**Three Oaks Recreation Area – Cable Wakeboard Park
Project Review for Planning and Zoning Commission**

Meeting Date:	August 21, 2013
Zoning Requests:	Conceptual Plan Review for a cable wakeboard park at Three Oaks Recreation Area.
Location:	5517 Northwest Highway
Acreage:	Approximately 475 acres
Existing Zoning:	M- Manufacturing
Surrounding Properties:	North - “Various” Commercial uses South - “LITH” Mining East - “Various” Restaurant, residential, manufacturing West - “Various” Manufacturing
Staff Contact:	Michelle Rentzsch (815-356-3615)

Staff Comments:

Overall Concept Plan - Enlargement

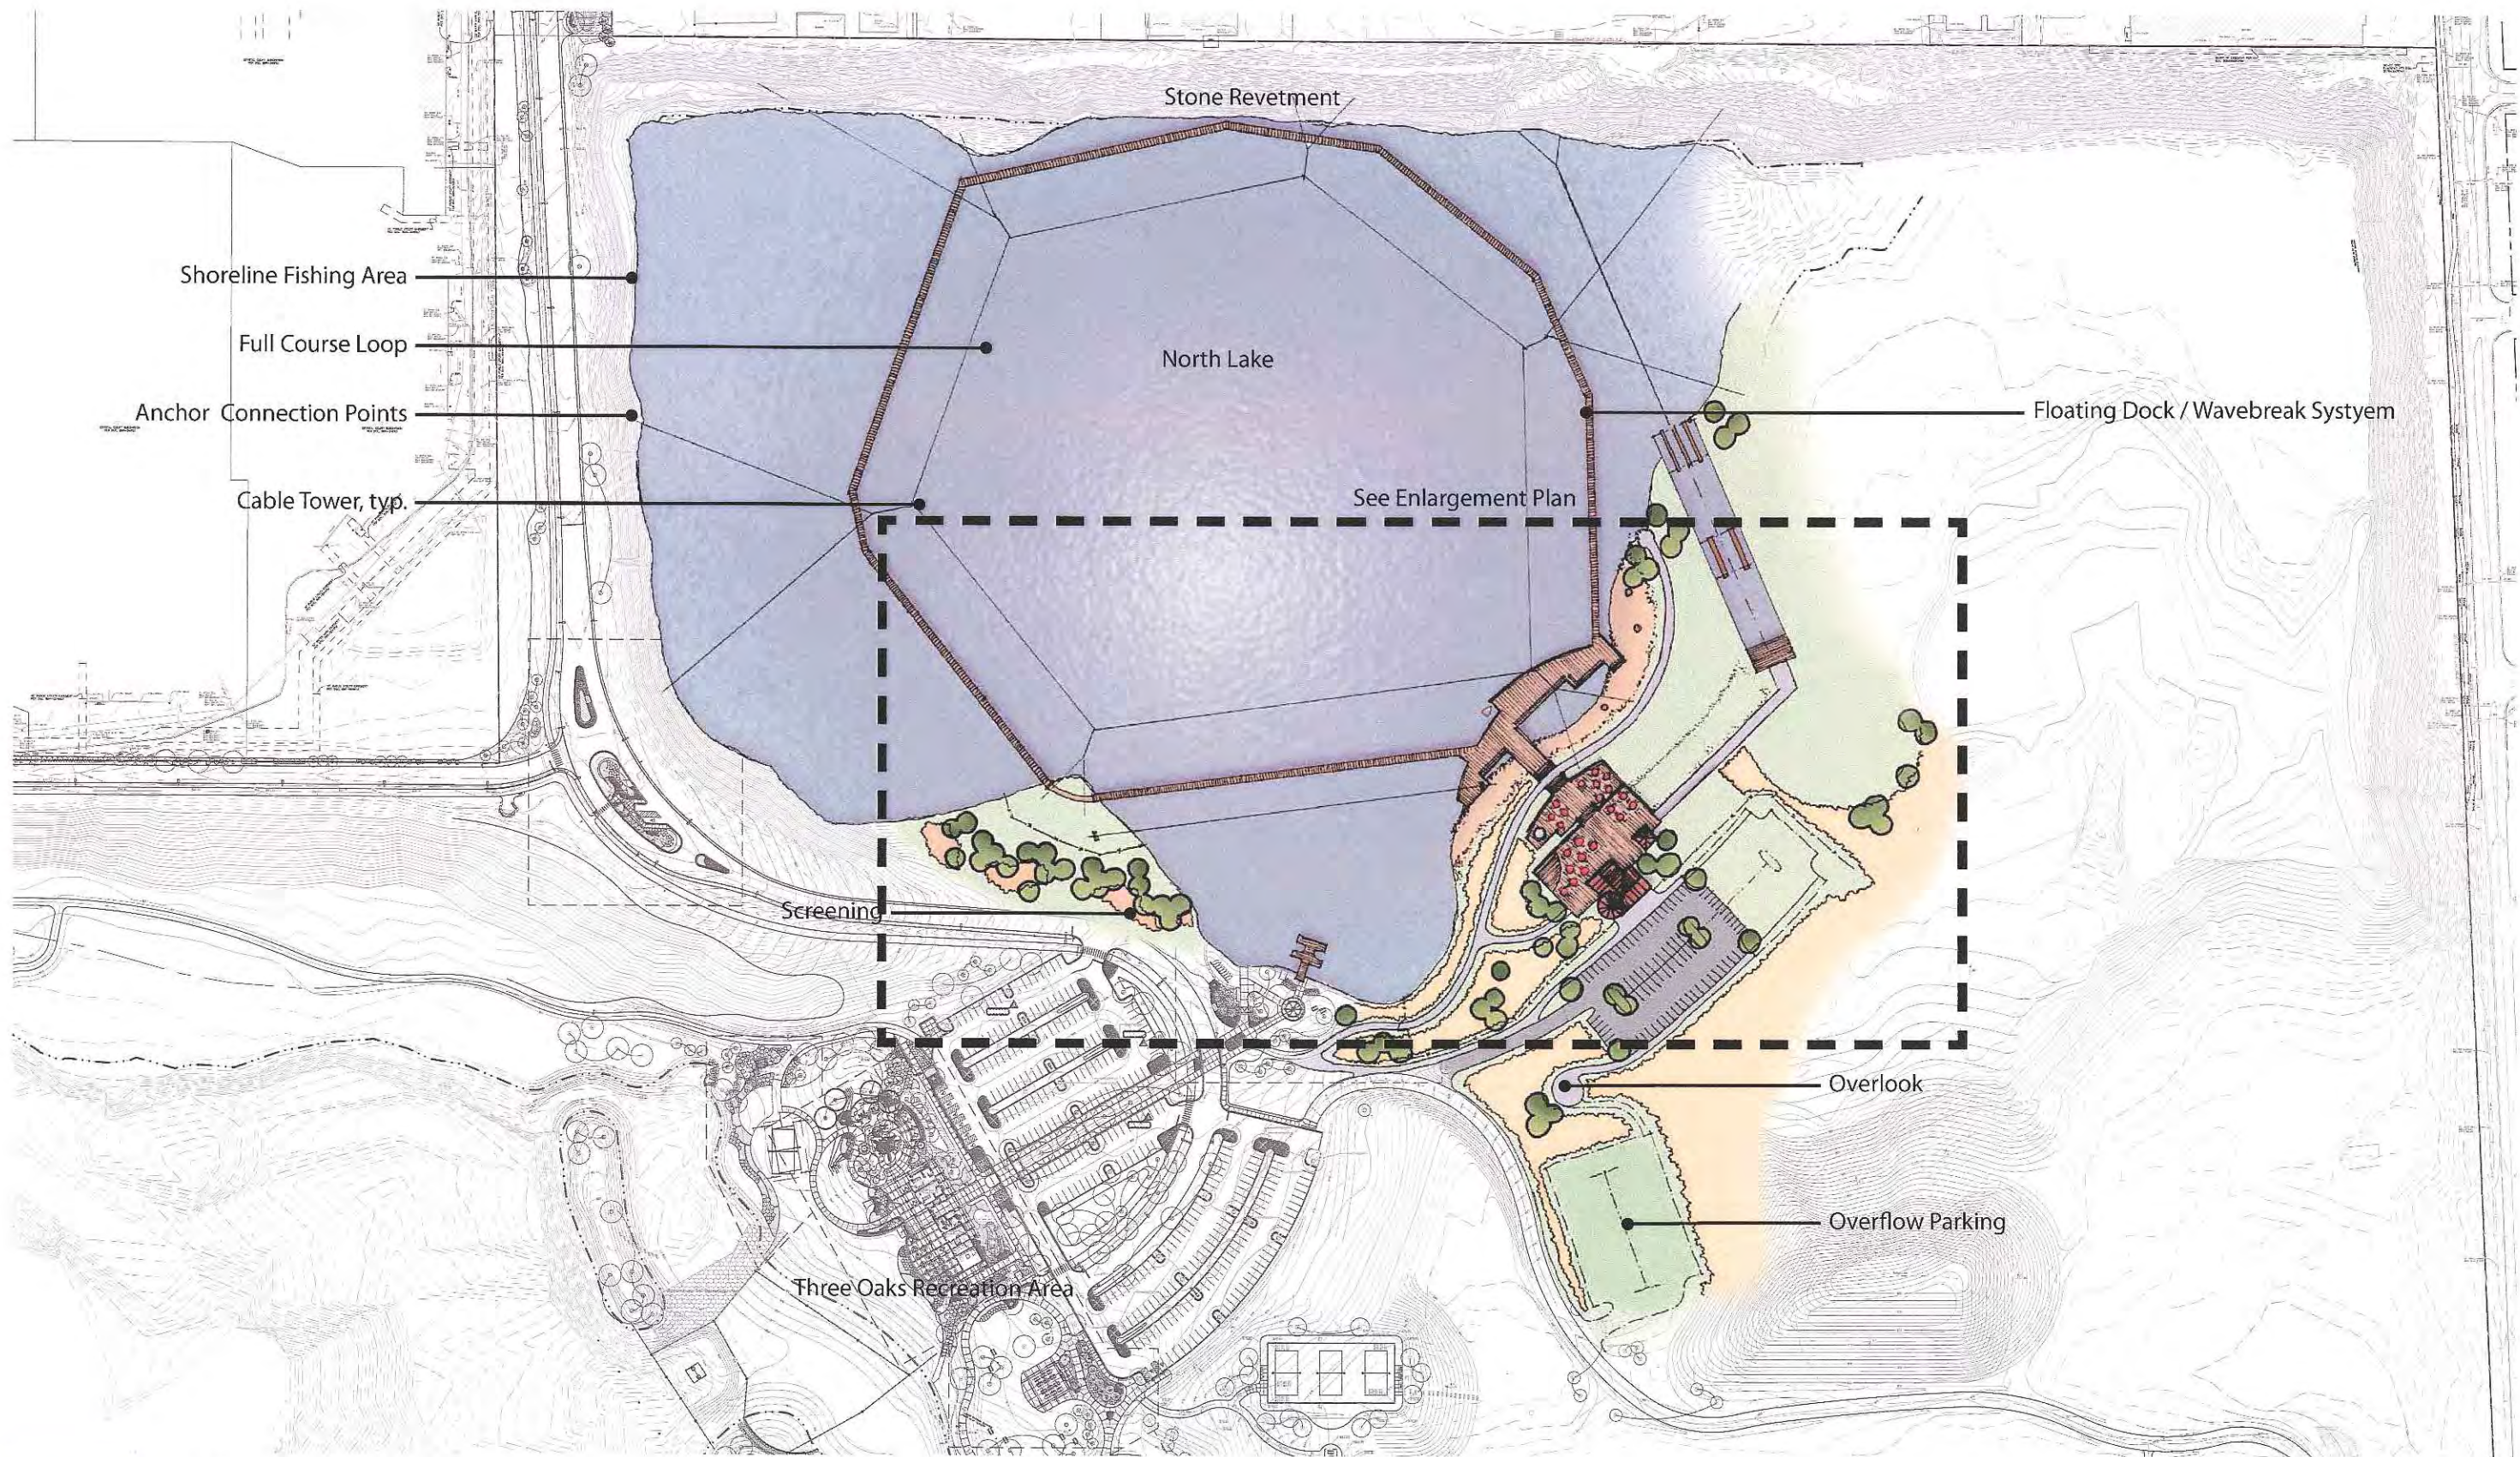
- a) The drive aisle connecting the new parking lot to the existing parking lot needs to be paved and not connect into the existing limestone path. [TRAFFIC STUDY COMMENT]

- b) Add 90-degree parking stalls on one side of this aisle for additional overflow parking.
- c) Provide pedestrian crossings across the driveway for the gravel path that leads to the sled hill and Pingree Road. [TRAFFIC STUDY COMMENT]

- d) Add wayfinding signage at the first and second intersections to direct guests to and from the wakeboard park parking lot. [TRAFFIC STUDY COMMENT]
- e) Suggest including the grading for a much larger “future” parking area in the initial phase to make expansion easier in the future. Could also serve a separate future building by the City (community room, banquet facility, etc) or for another private recreational use.

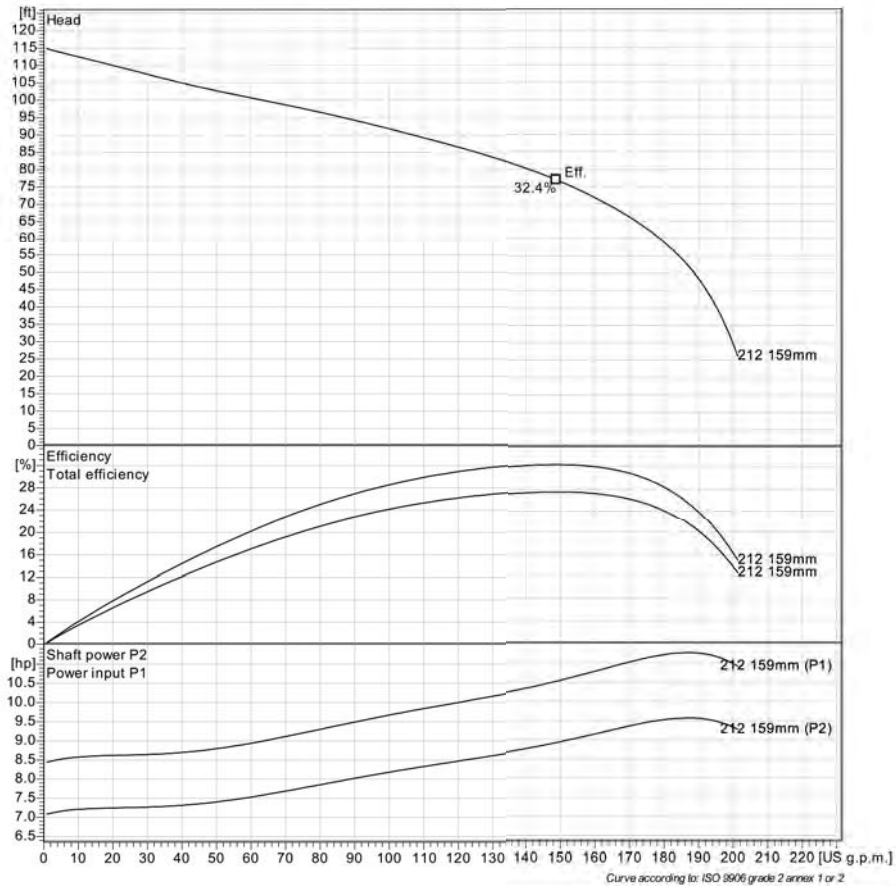
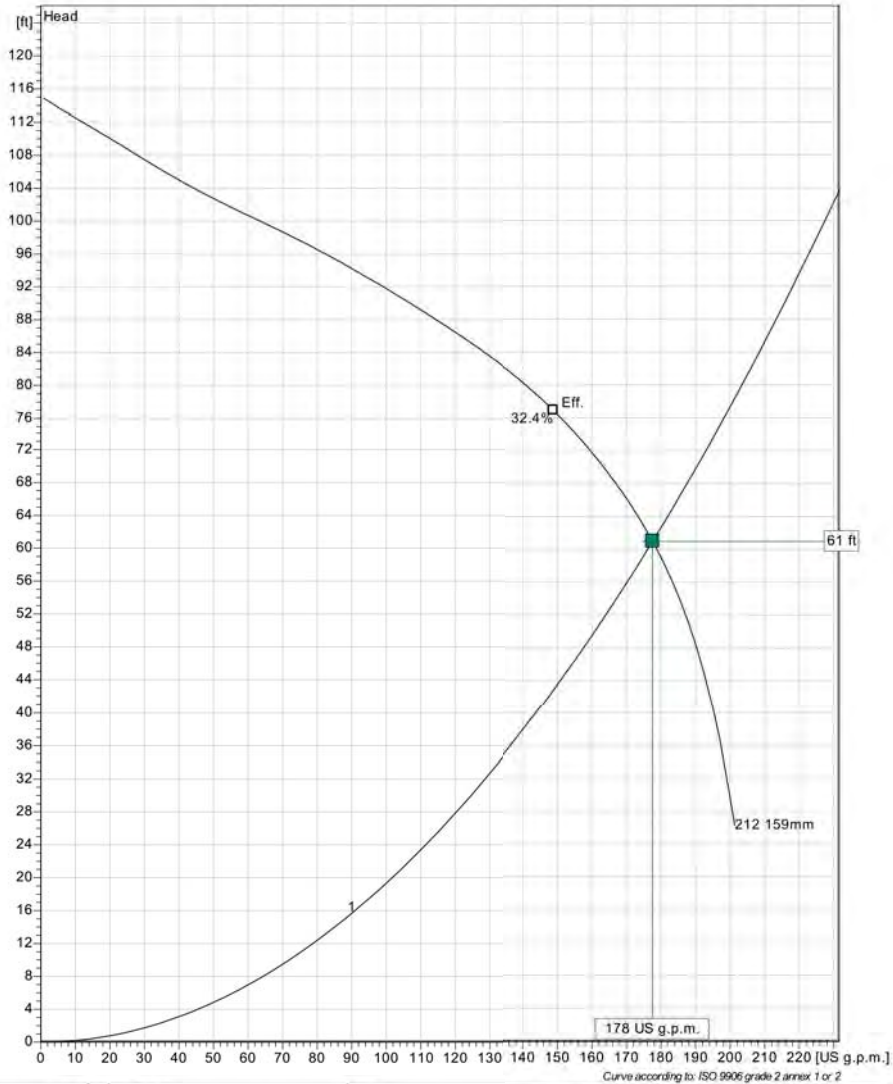
3) Sanitary Sewer: With the building located lower than the location shown in the feasibility study, additional design needs to be completed to show whether a gravity sewer is still possible. A separate lift station would add additional cost and maintenance. Also need to confirm the size/capacity of the sanitary force main (4’’?).

Sewer - Page 3 of the Project Narrative states the existing forcemain “should be adequately sized to handle the additional flows from this facility.” The following sentence states the pumps and wet well will be evaluated for any needed modifications. The forcemain should be a part of the evaluation as well.
